**AGENDA
TECHNICAL REVIEW COMMITTEE
REGULAR MEETING
MARCH 27, 2025
10:00 AM
CITY HALL COMMISSION CHAMBERS
204 ASH STREET
FERNANDINA BEACH, FL 32034**

- 5. DISCUSSION ITEMS**
- 6. OLD BUSINESS**
- 7. NEW BUSINESS**
 - 7.1 **TRC 2025-0001 - GILLETTE & ASSOCIATES, AGENT FOR WORTHY INVESTMENTS LLC, 124 S. 3RD STREET, 119 S. 4TH STREET, 123 S. 4TH STREET, & 125 S. 4TH STREET**
Site plan review for the construction of four triplex units.

Project Type*	Project Name
Site Plan Review	Third & Beech Triplex

Date: 03/13/25
Project No. 24-10-XX
Sheet: UT-1
Page 6 of 12

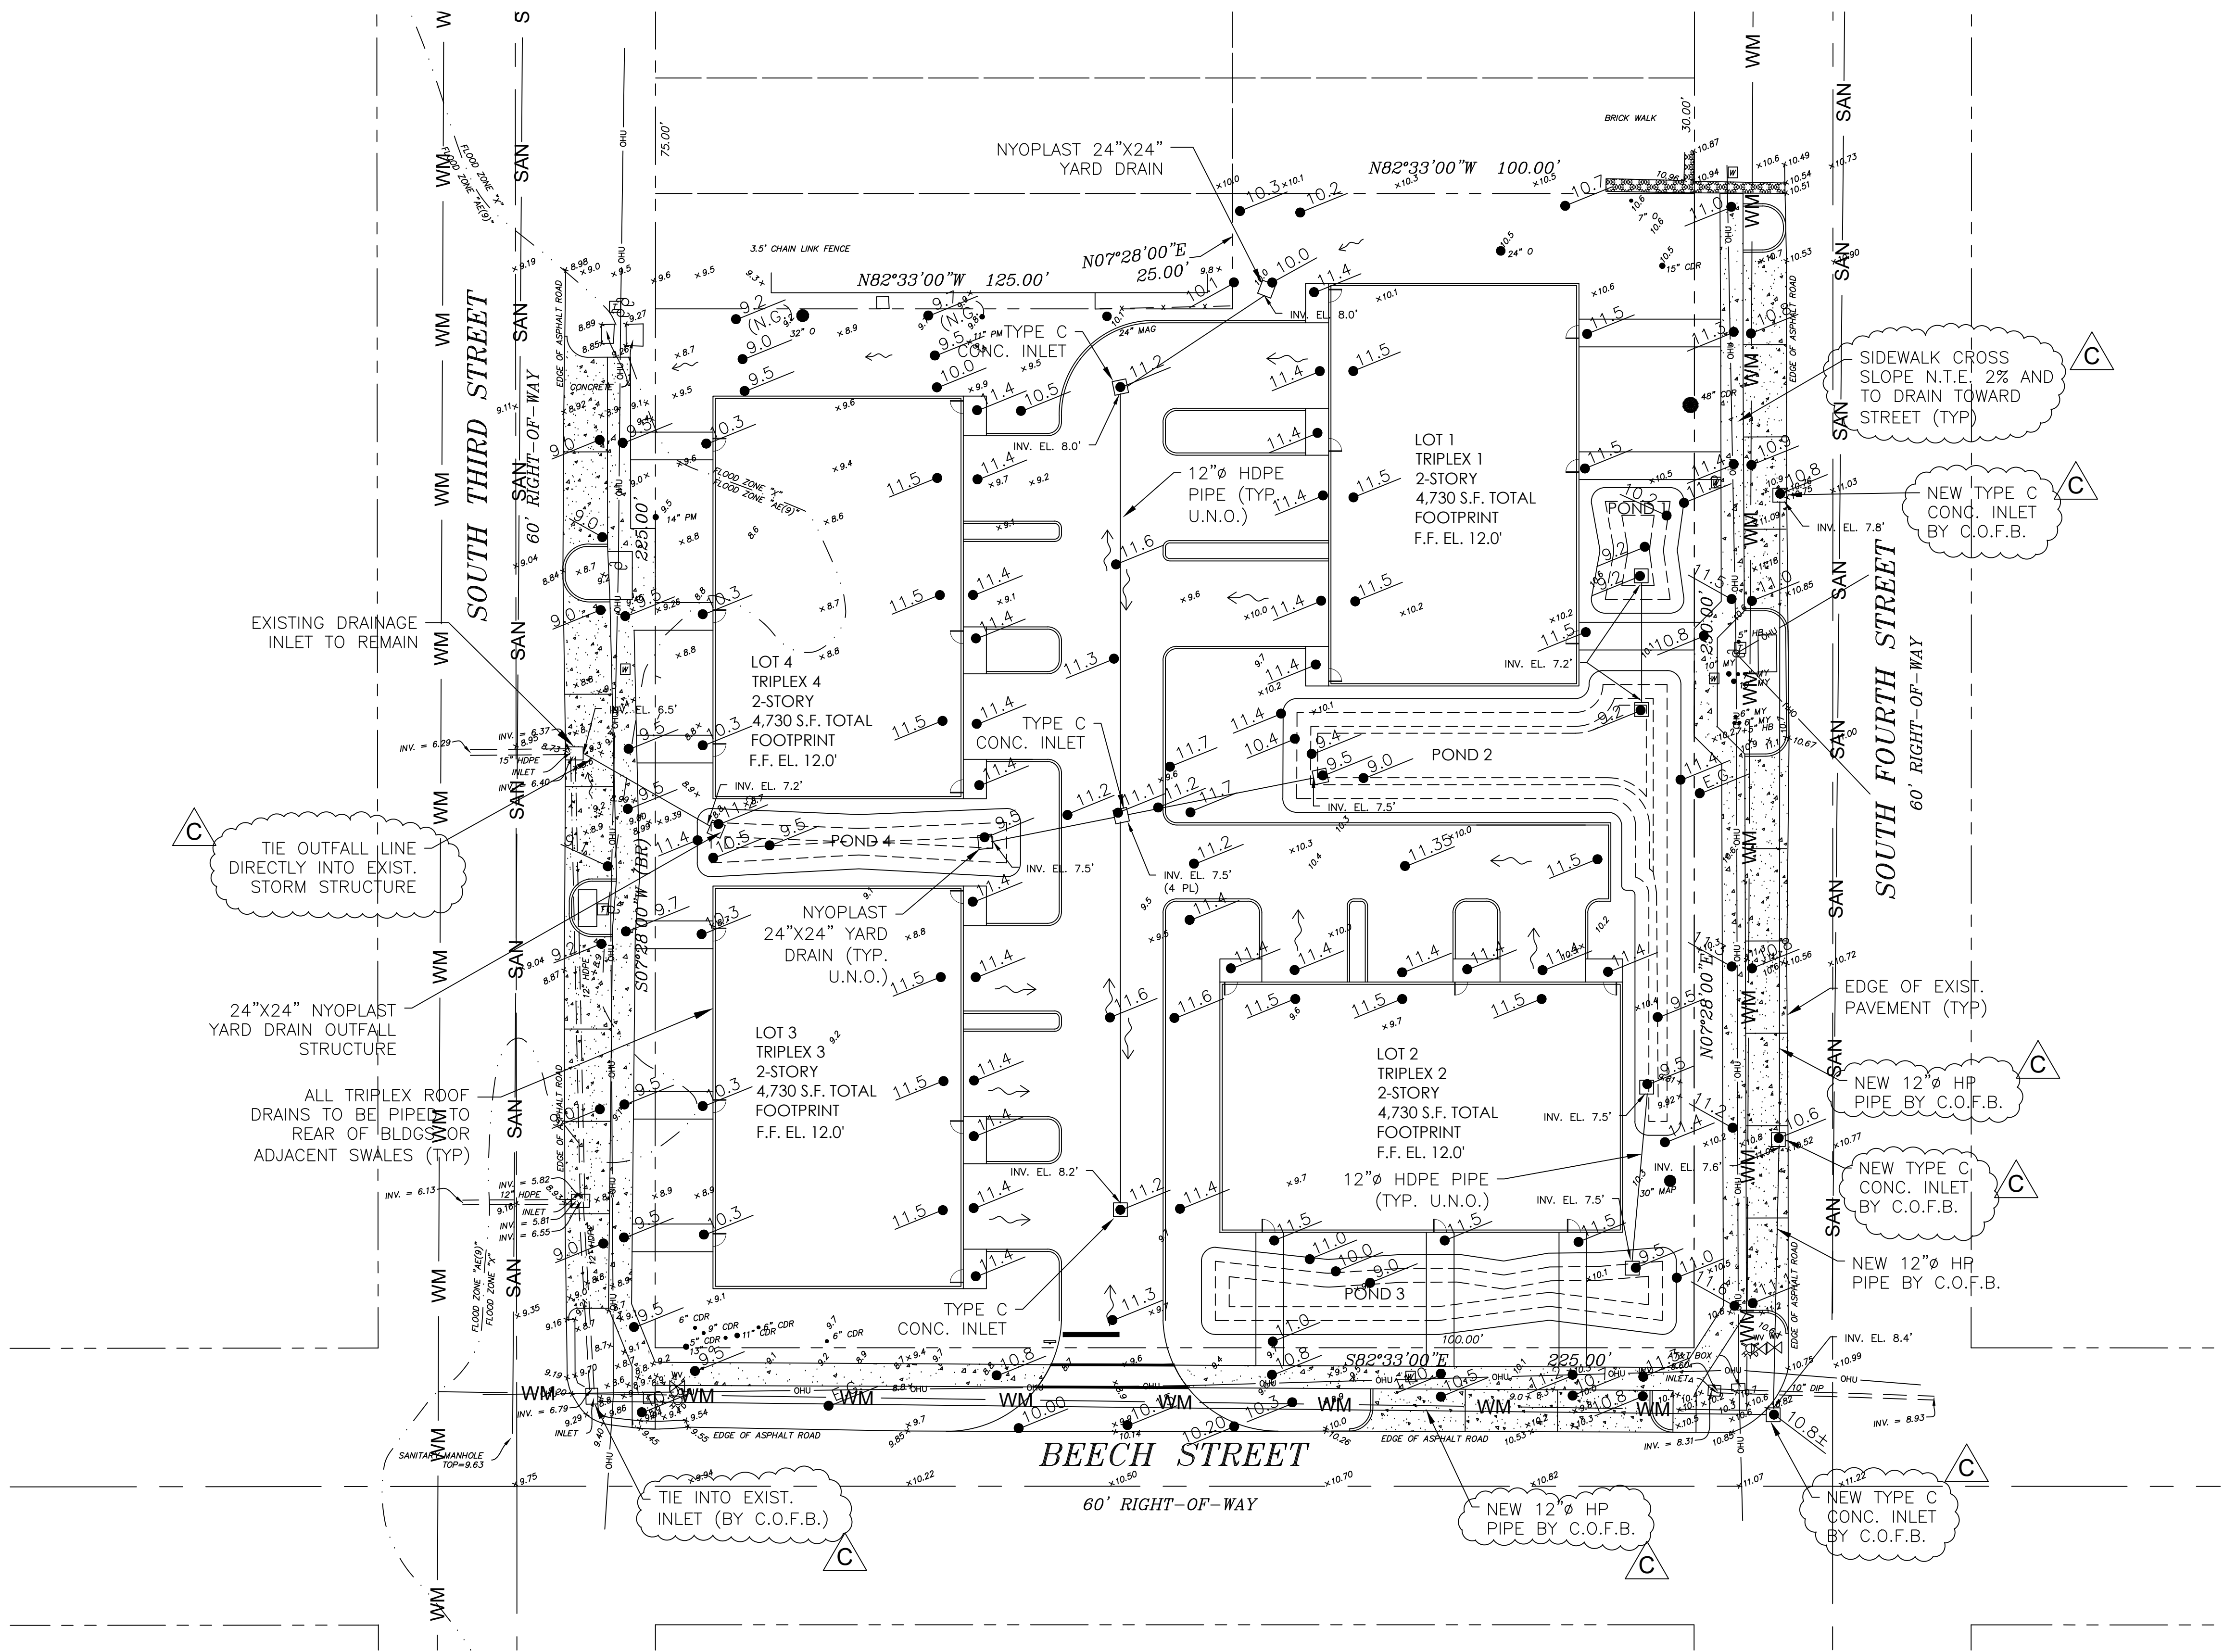
- **Two times existing water meters are noted but not shown on the plans. Please include them.**

That layer was inadvertently frozen and now shows on Sheet UT-1
